TO: Firms Interested in the Goldston Library Addition

SUBJECT: Addendum No.3– Goldston Library Addition

RISER DIAGRAM

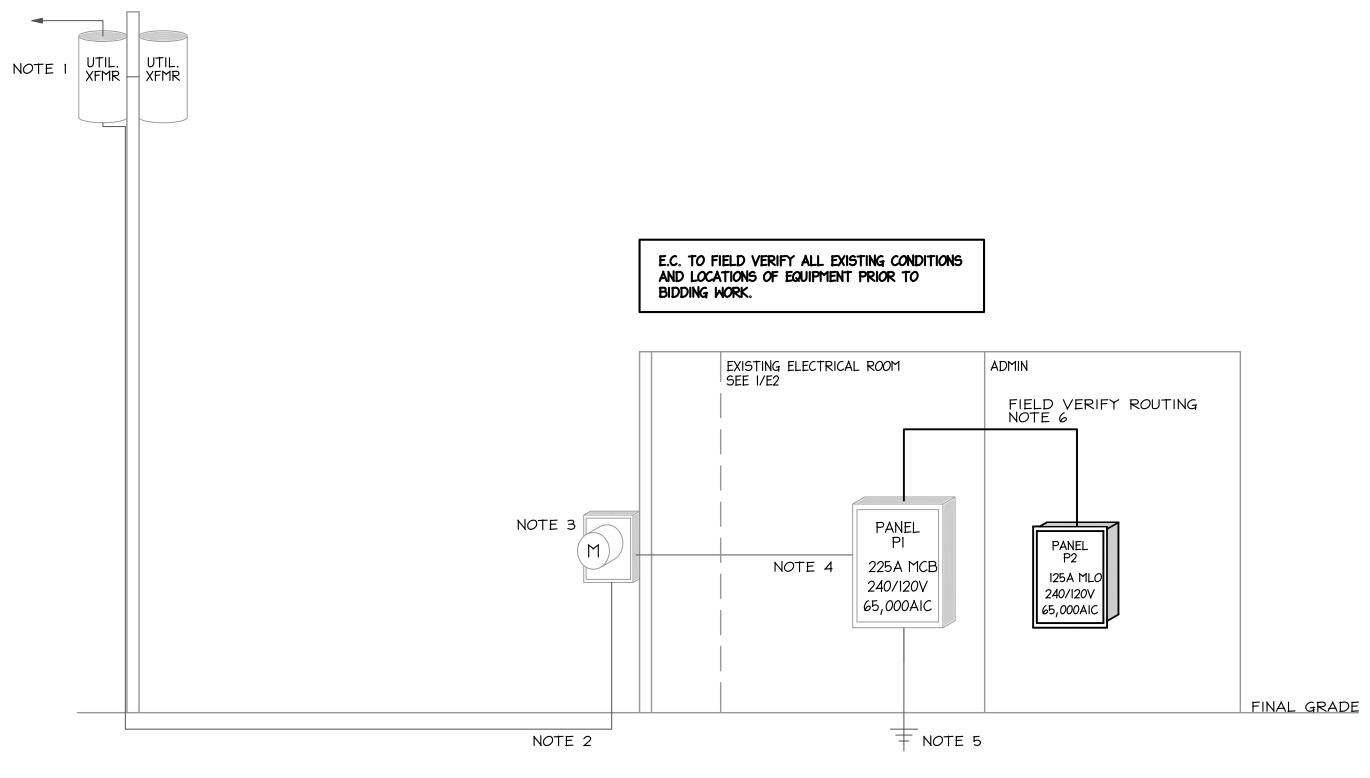
1. **Q:** The existing service is 225-amp 240/120 volt single phase with a new remote panel sized at 100 amps 240/120 volts. The calculated load for the new addition would exceed the 100 amps and also would cause the main panel to exceed 225 amps.

**A:** See the Mechanical and Electrical drawings attached. Both disciplines reflect what will be on the permit set, even though the Mechanical only shows some air flows that will be needed for permit, but don't affect the design, or cost.
